# UNITED STATES PATENT AND TRADEMARK OFFICE

APPLICATION NO.	FILING DATE	FIRST NAMED INVENTOR	ATTORNEY DOCKET NO.	CONFIRMATION NO.
10/032,959	10/24/2001	Diane M. Landers	DP-306554 / DE3-0257	7053

<b>Office Action Summary</b>	<b>Application No.</b> 10/032,959	<b>Applicant(s)</b> LANDERS ET AL.	
	<b>Examiner</b> Sean P. Shechtman	<b>Art Unit</b> 2125

FIG. 55A

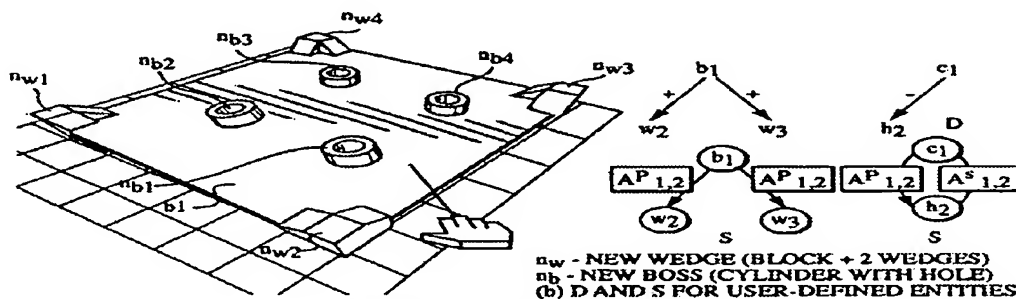
Gadh clearly teaches a design intent graph (D) used to create a design and record the specified design constraints to be used in future design activities. Clearly, D refers to the intended/desired geometric relations between the models features (Col. 20, lines 56-65). Gadh clearly teaches exemplary embodiments of a “machined part constructed in VDSF” with its corresponding D (Col. 36, lines 28-34).

Clearly, the D depicted above, is horizontally structured. The virtual blank is element b1, and a manufacturing feature could clearly be any of nw or nb with exclusive relationships to b1. Gadh clearly teaches elements as add-ins, wherein, as mentioned above, the figures depict “a machined part constructed in VDSF”. Gadh clearly shows the manufacturing features on a grid coordinate system. Furthermore, Gadh clearly teaches a child element (which can clearly be interpreted, without question, as any of the nw or nb elements) has an associative relationship with the coordinate system. The VDSF display viewed by the user is considered as having a right-left/top-bottom/front-rear coordinate system, whereby the user issues intuitive commands for a user-viewpoint-dependent method of alignment of said child element. And, Gadh also
